**Re: Notice of *Ex Parte* Presentation - Application of ViaSat, Inc.; FCC File Nos. SES-LIC-20120427-00404 and SES-STA-20120815-00751 (Call Sign E120075)**

# Presentation Concerning ViaSat Ka-band AMSS Proposal

**Figure 1 – Mantarry M40 Front View**

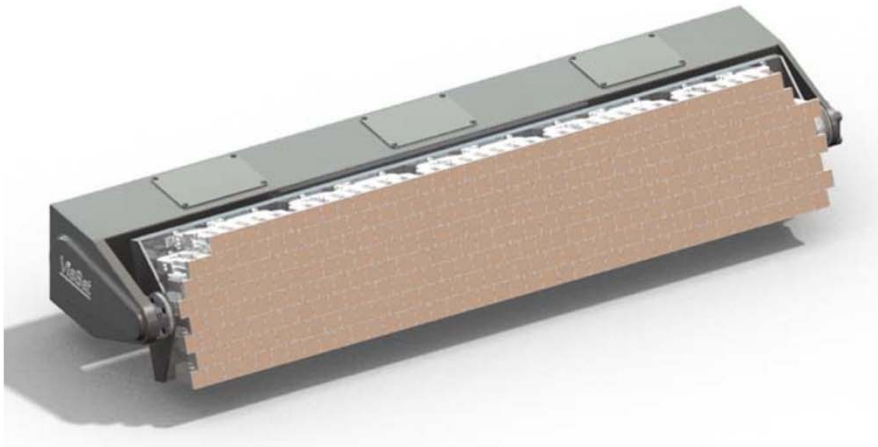
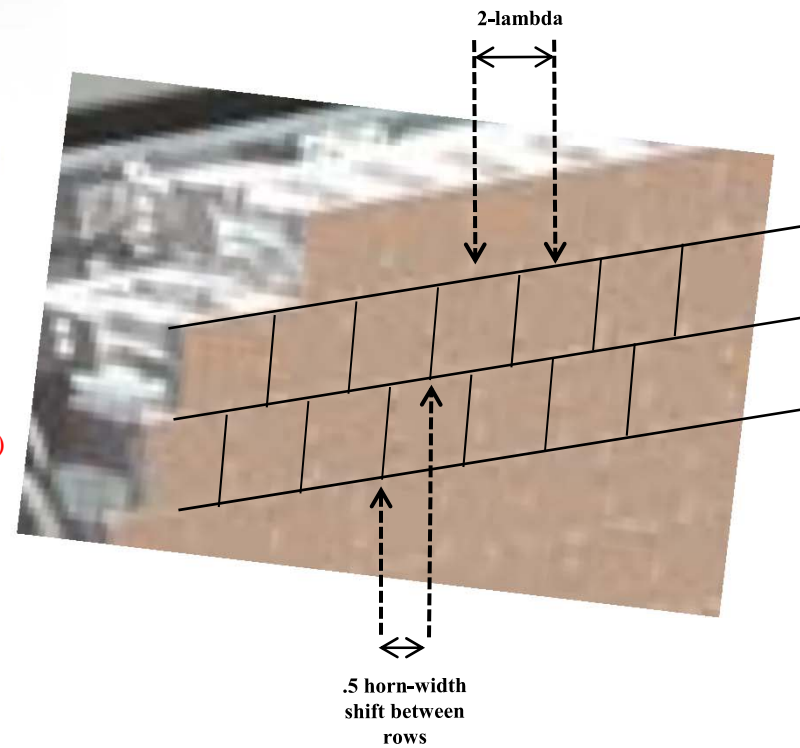
- ViaSat's use of 2-lambda horn spacing in its antenna is a design flaw that produces the variable grating lobes evidenced in ViaSat's own off-axis EIRP plots (1-lambda horn spacing is recognized as necessary to avoid generating grating lobes, and Ka-band antennas can meet this standard);

- In the Mantarray design, ViaSat seeks to suppress the grating lobes by off-setting each row of horns by one-half the width compared to the adjacent rows, but based on ViaSat's plots, the grating lobes are not fully suppressed even at zero degrees of antenna skew;

Mantarray M40 RHCP Measured Tx Antenna Pattern Cuts, Skew = 0, Freq = 28.35 GHz, Power = 30.5dBW/40kl

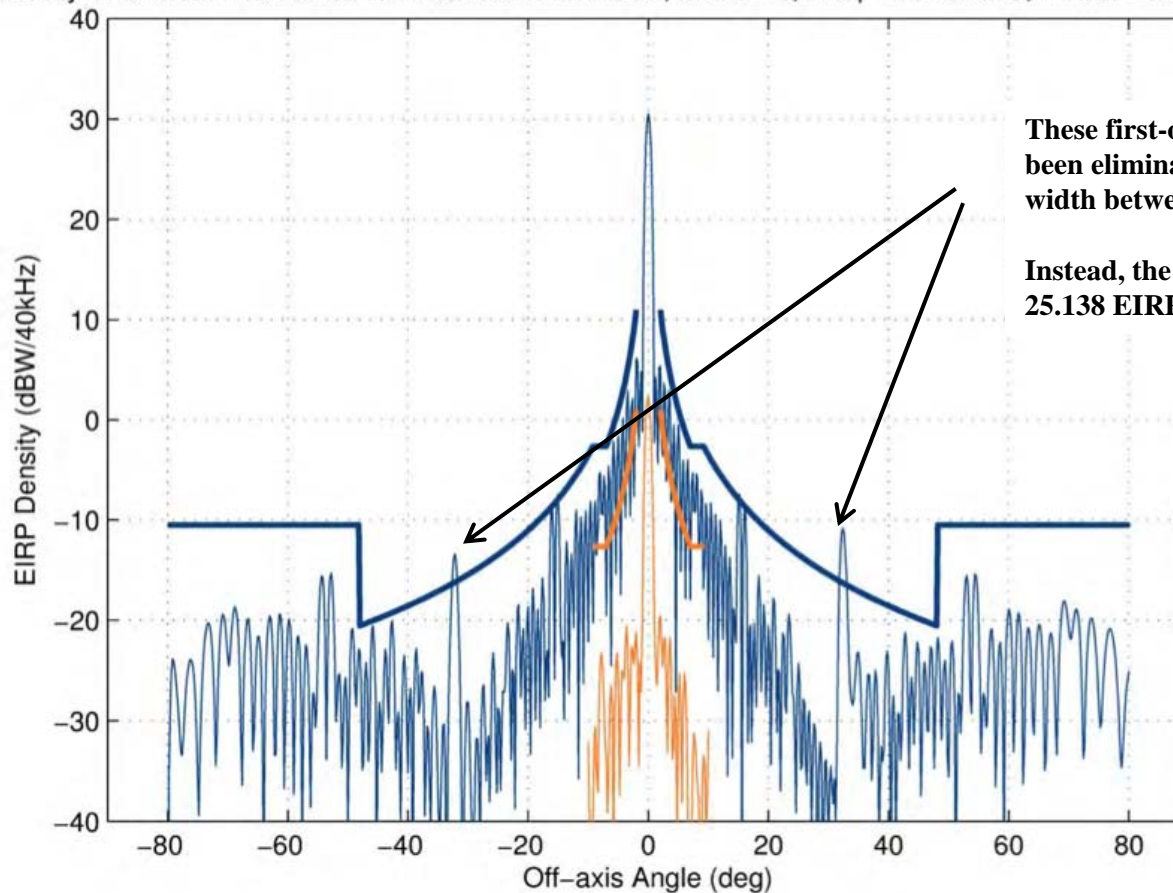
These first-order grating lobes should have been eliminated by shifting the horns .5-width between rows.

Instead, the lobes are present, violating the 25.138 EIRP limits by 5 dB.

Mantarray M40 LHCP Measured Tx Antenna Pattern Cuts, Skew = 25, Freq = 28.35 GHz, Power = 30.5dBW/40k

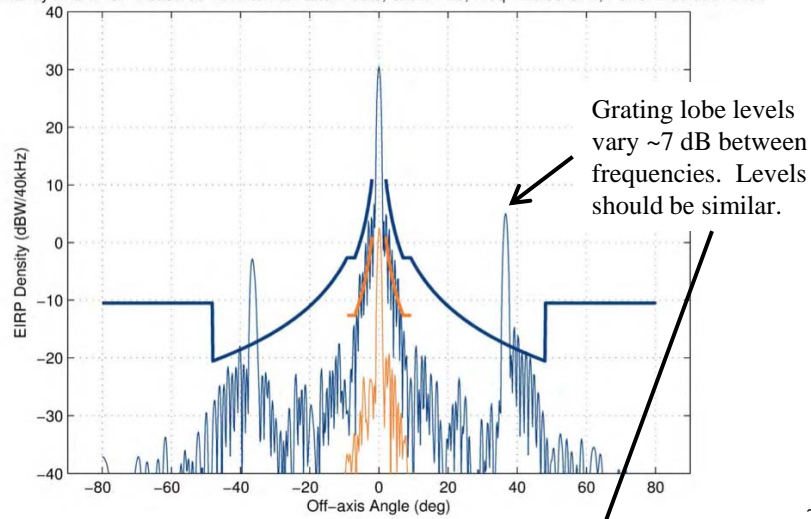
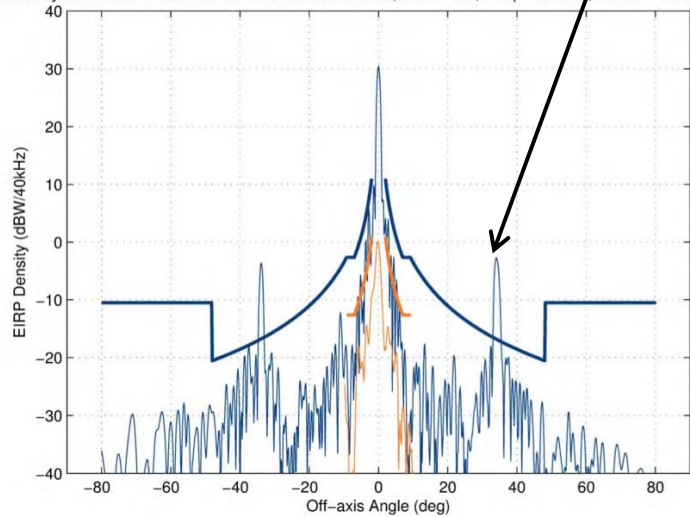
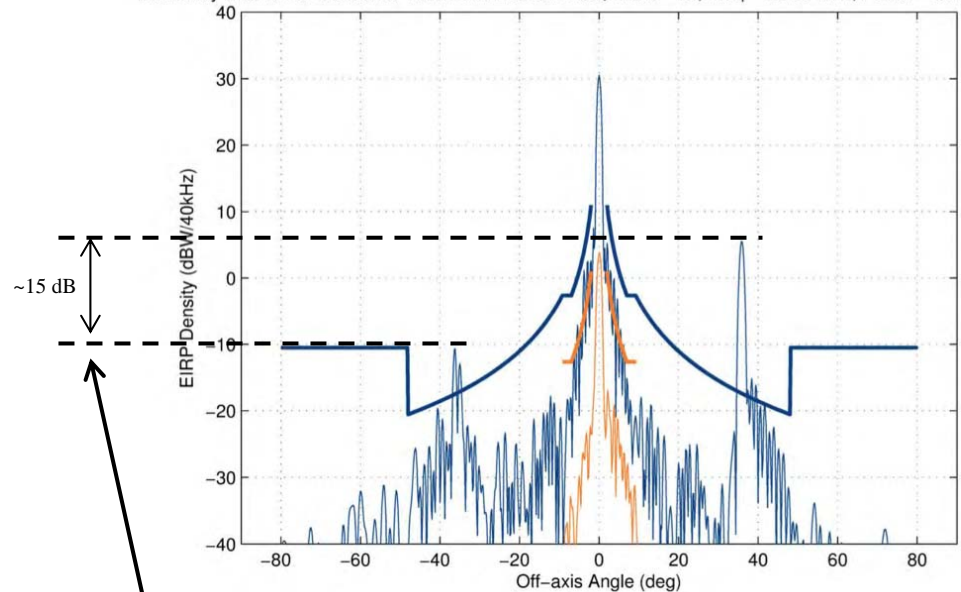
~15 dB level variation exists between grating lobe levels for the same TX frequency. These levels should be similar.

# CALCULATING ANTENNA POINTING ERROR

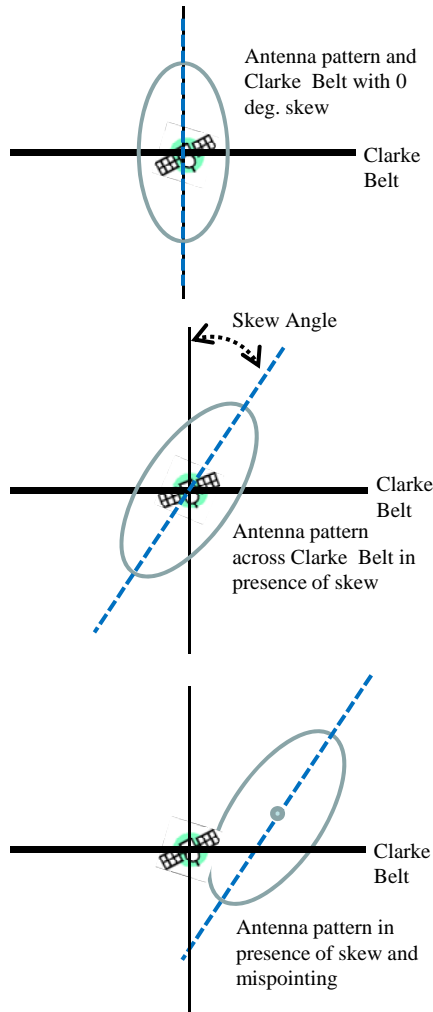
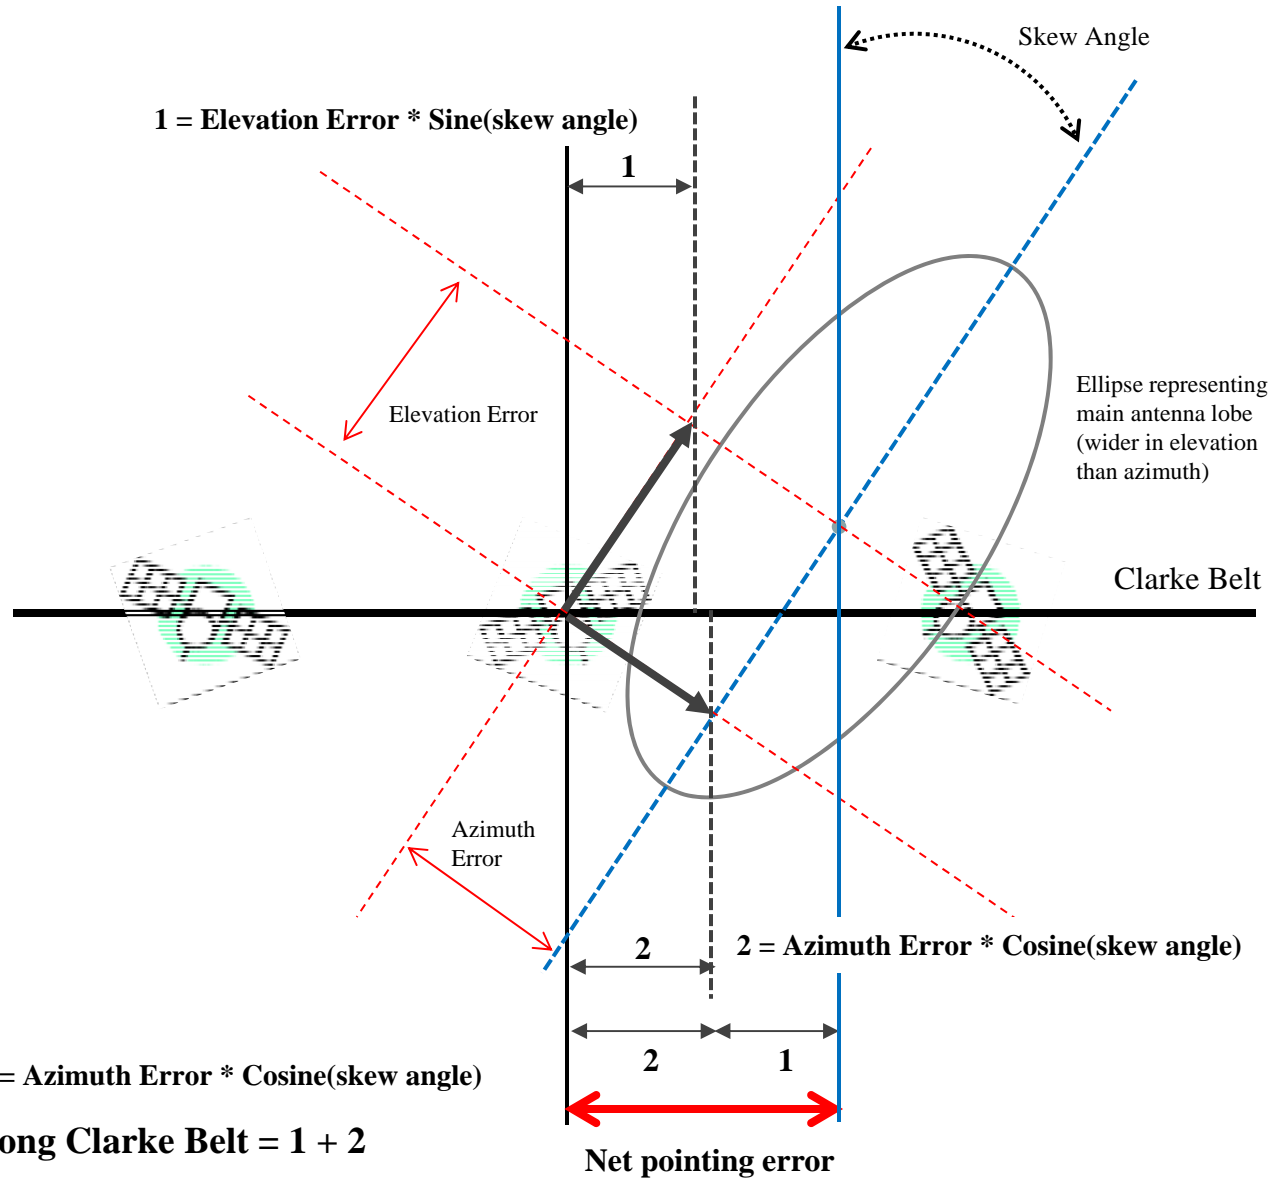
- ViaSat's technical analyses have consistently ignored the additive impact of mis-pointing/mis-orientation in both azimuth and elevation, considering only the former, but not the latter, in assessing the potential interference impact of its proposed network; and

- Analysis that takes into account mis-pointing/mis-orientation in both the azimuth and elevation planes shows that at 40 degrees of skew, the ViaSat antenna would be in violation of the 0.5 degree mis-pointing limit almost 10% of the time, and would exceed this pointing error threshold approximately 20% of the time at 60 degrees skew.

Pointing error is the projection of both azimuth and elevation error along the Clarke Belt
